**March 7, 2024**  
**Planning Commission**  
**Regular Meeting**  
**Information Packet**

# The Estates at Twenty Wells PUD Summary and Recommendation

# West Haven PUD / Rezone Summary and Recommendation

Figure 4-1. Existing Flood Protection Infrastructure

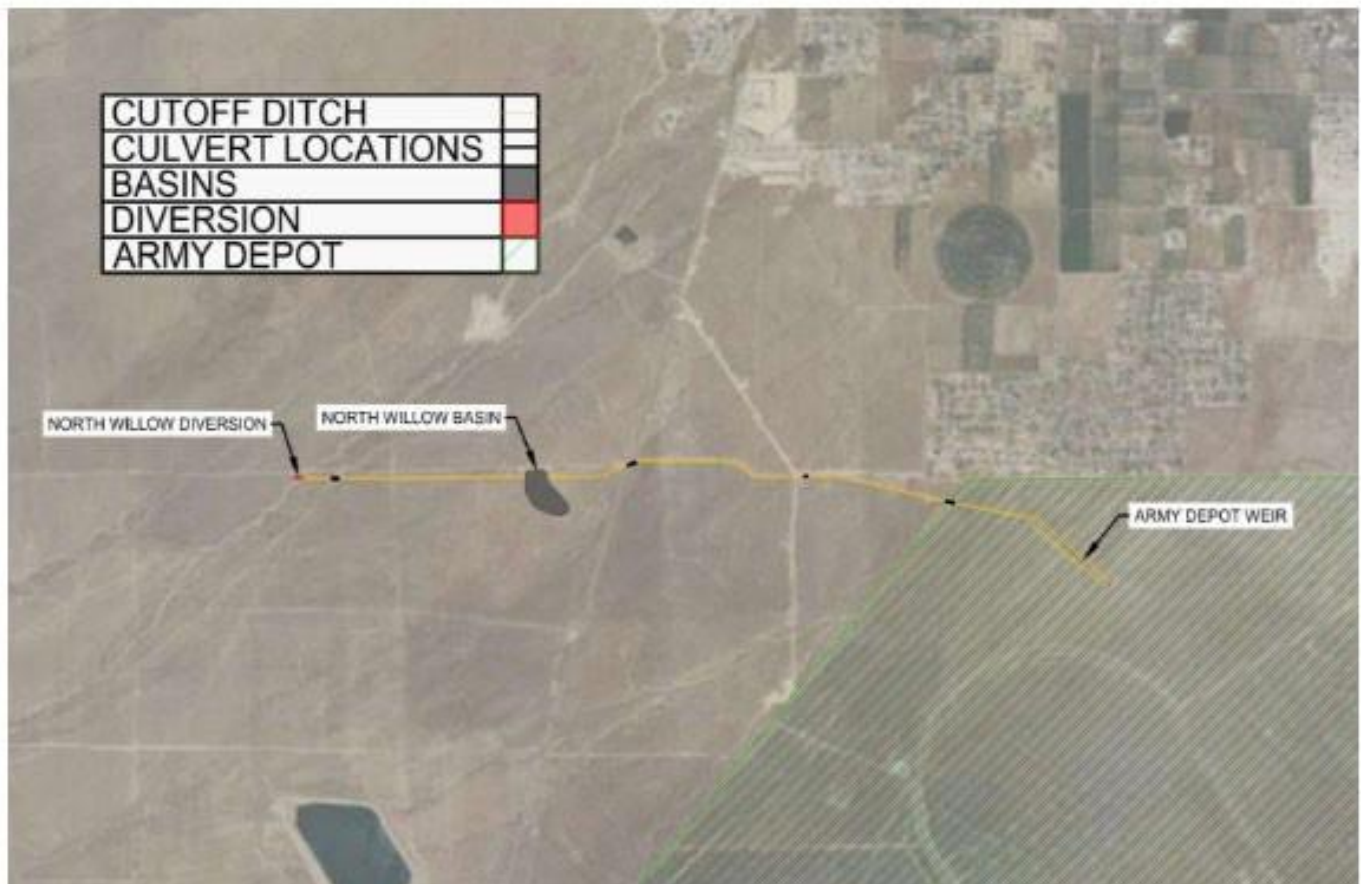
- The drainage study for offsite and onsite storm water will be crucial.
- Soils are noted as silty loam and silty clay loam. Infiltration will need to be confirmed with a geotechnical report and percolation tests.
- Main offsite drainage through the project will be conveyed along Mallory Way via roadside swales. These drainage channels have stormwater runoff through the Tooele County and Army Corps flood protection facilities from South Willow, Coal Pit, and North Willow Canyon along with West Army Creek and East Army Creek drainage areas, see images below.

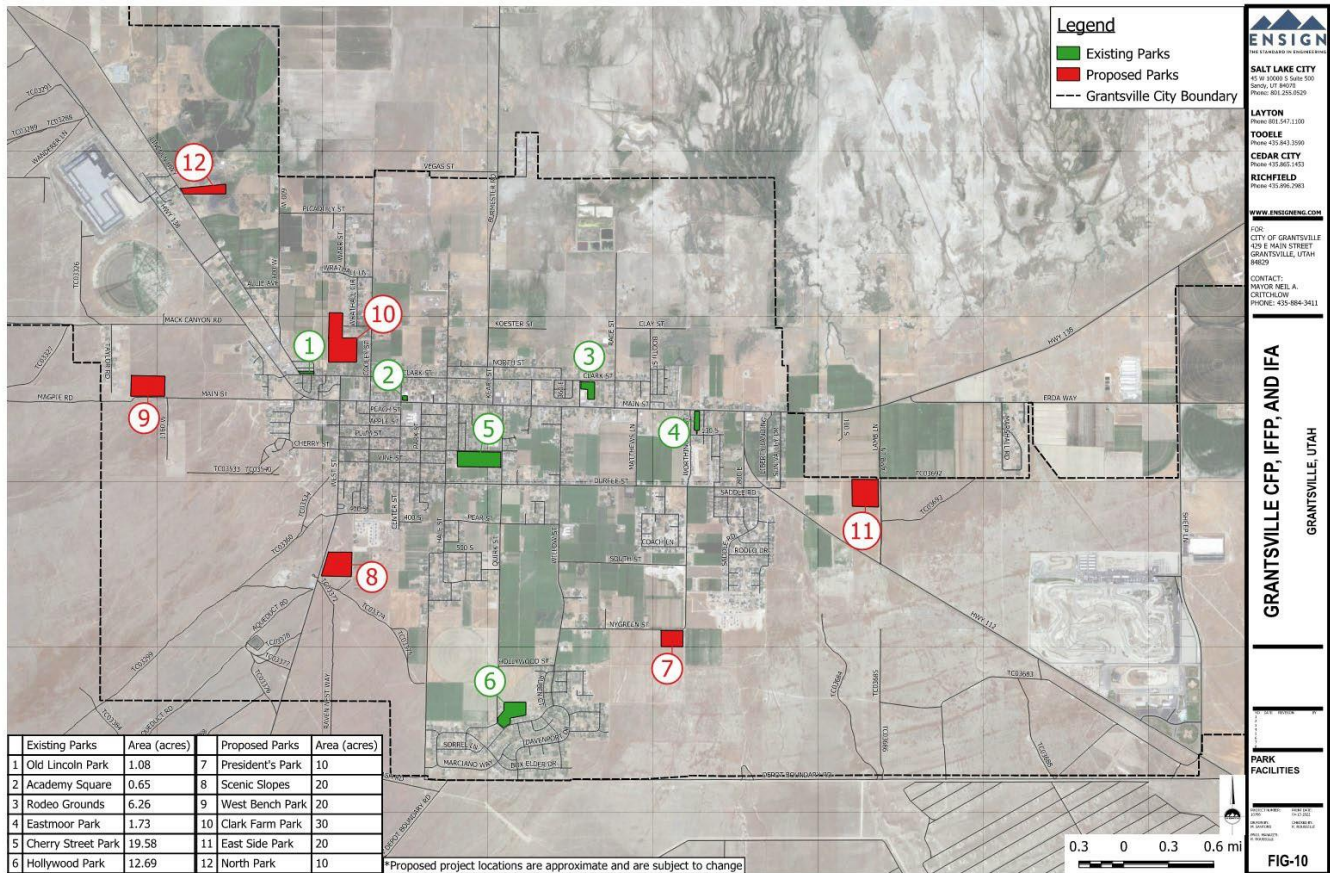
- When taking in consideration the water line connections of Nygreen Street and Durfee Street, the 12-inch water line through the development connecting to the 16-inch transmission line along the north Depot property could have been an 8-inch to address fire flow. However, the developer is proposing the 12-inch upsize to benefit other future developments. Installation of an additional connection off the 16-inch transmission line provides opportunities for additional development along SR-112 while allowing future benefits of looping with future water lines through Lakeview Business Park and along SR-112.

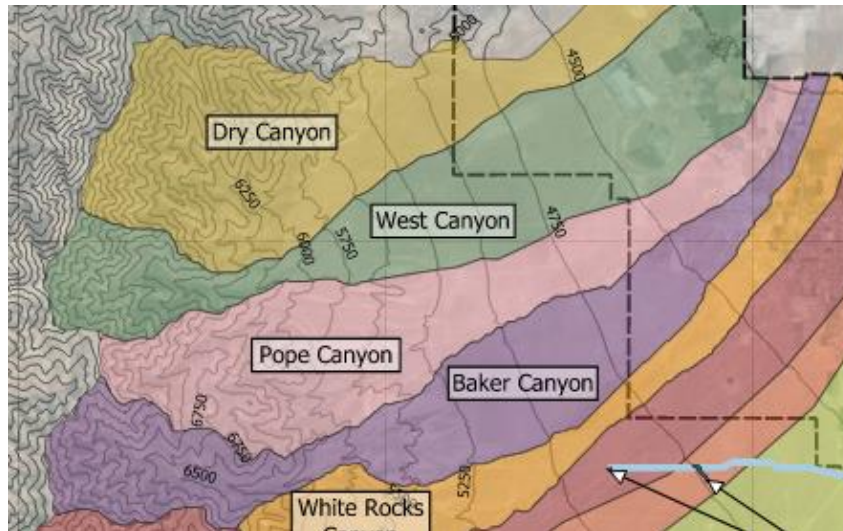
- The drainage study for offsite and onsite storm water will be crucial. This project conveys stormwater from the Baker Canyon Watershed, see figure below.

development is preserving the major drainage corridor through the development as open space. It is recommended to incorporate channel infiltration basins at road crossings to infiltrate this storm water. Once the drainage passes under an existing culvert under SR-138 it flows into industrial property. This is an existing condition.
